PUBLIC INTEREST REVIEW FOR GROUNDWATER APPLICATIONS

SUBJECT: Application G- 17899 Supersedes review of _____
Date of Review(s)

A. GENERAL INFORMATION: Applicant's Name: Glenn Harris County: Harney

Application G-17899, Glenn Harris

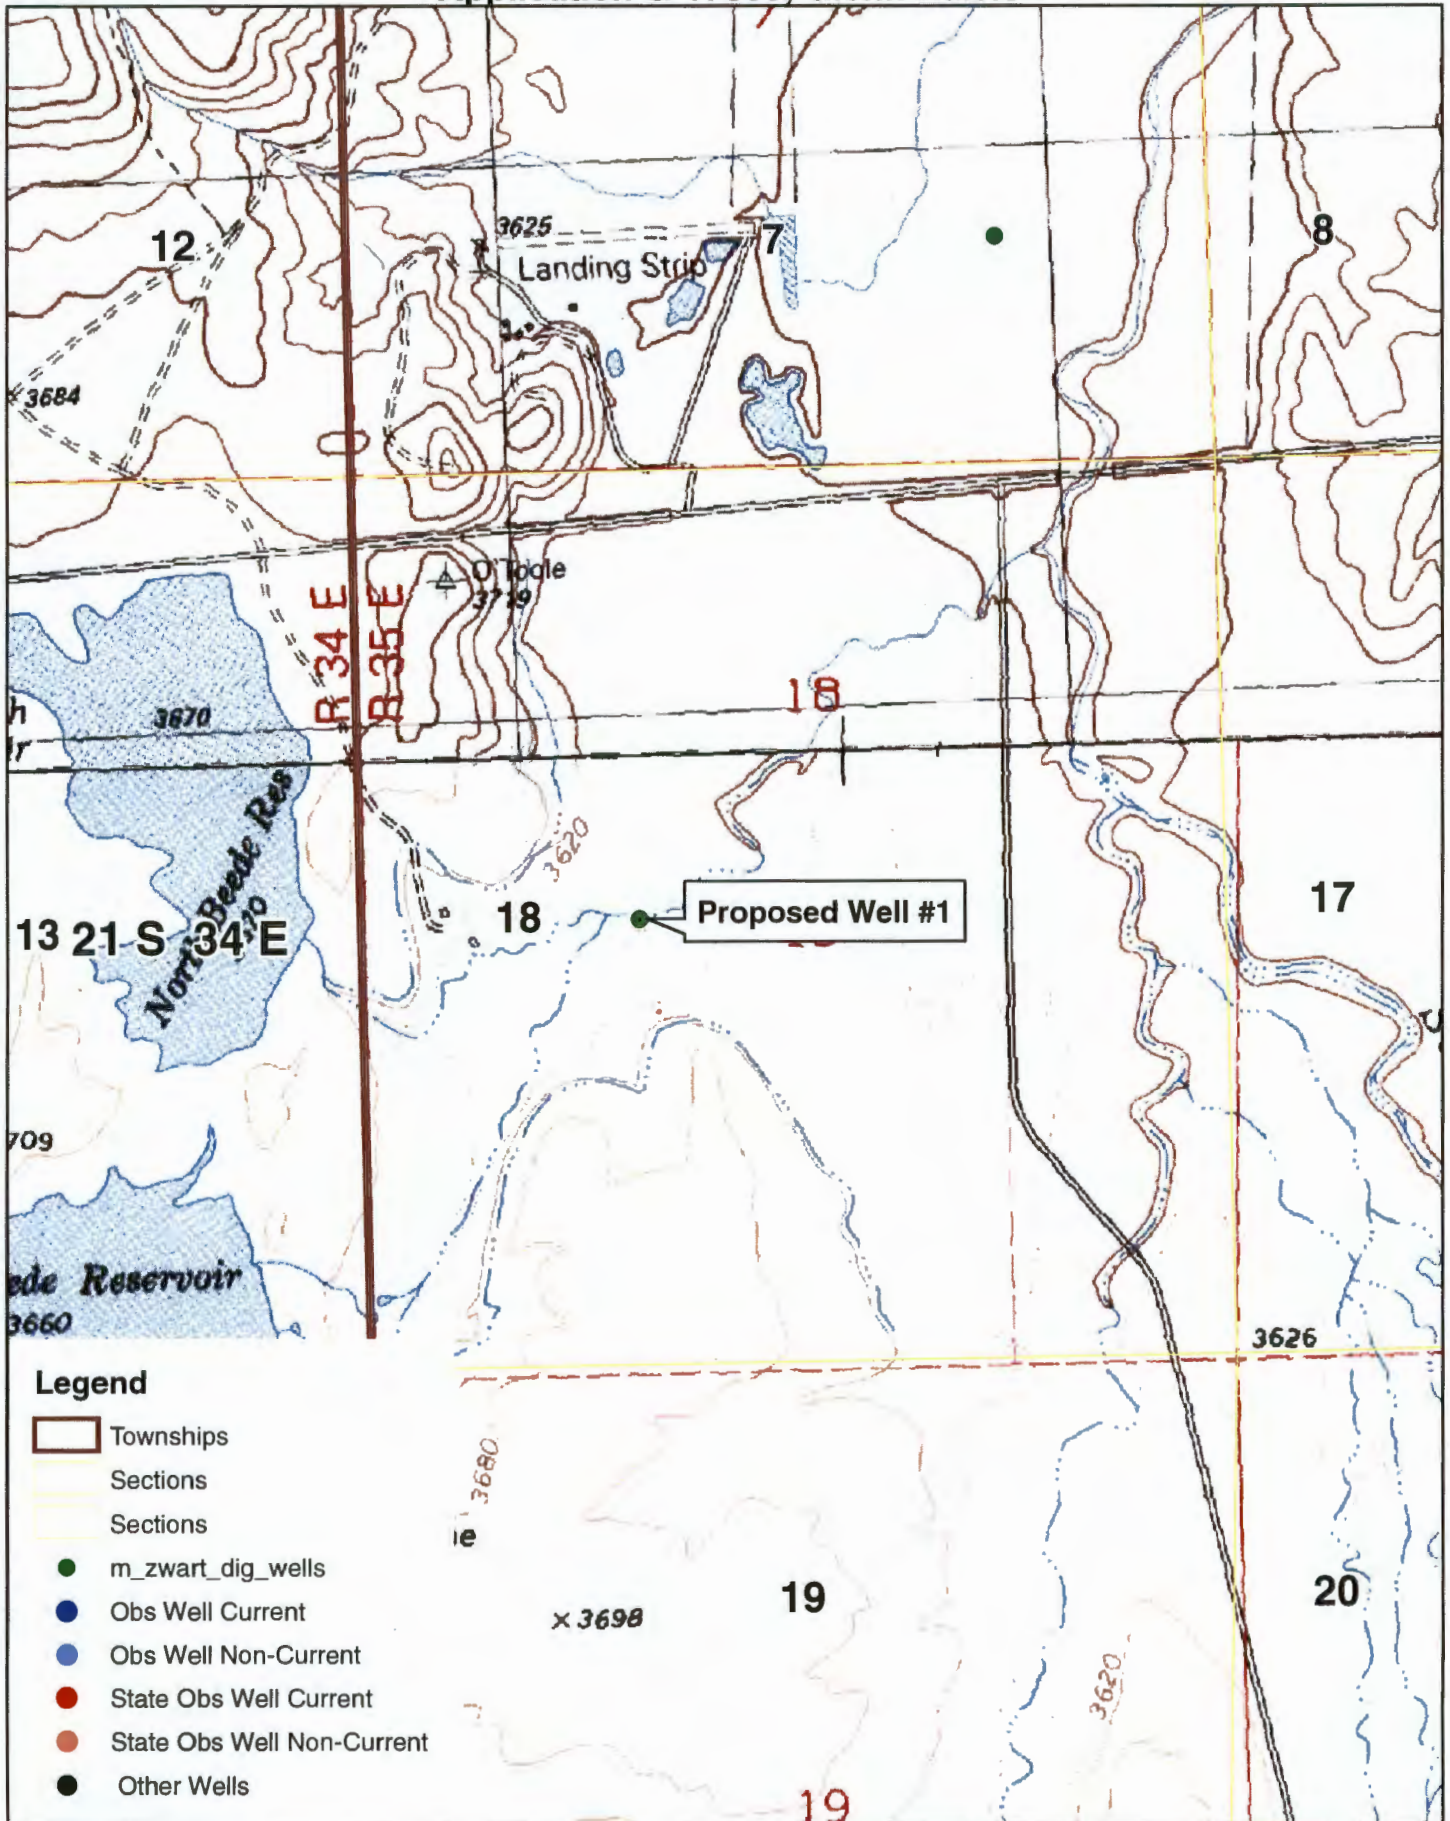
- B3. Ground water availability remarks: There are no nearby State Observation Wells or permitted wells with long-term water-level records. The area has not yet experienced significant development of the groundwater resource for irrigation. It appears that the proposed wells for nearby file G-17730 have not yet been constructed.

Well HARN 52112 may or may not be intended to be permitted under this application. The well constructor indicated that the water-bearing zone is from 7 to 315 feet in depth. I believe that this is erroneous. Comparison with nearby well logs HARN 52081 and HARN 52104 indicates that another well constructor reports only the basalt to be water bearing. Based on these well logs and my own professional opinion, it appears that the thick clay and claystone described in all these logs is a confining layer rather than a water-bearing zone.
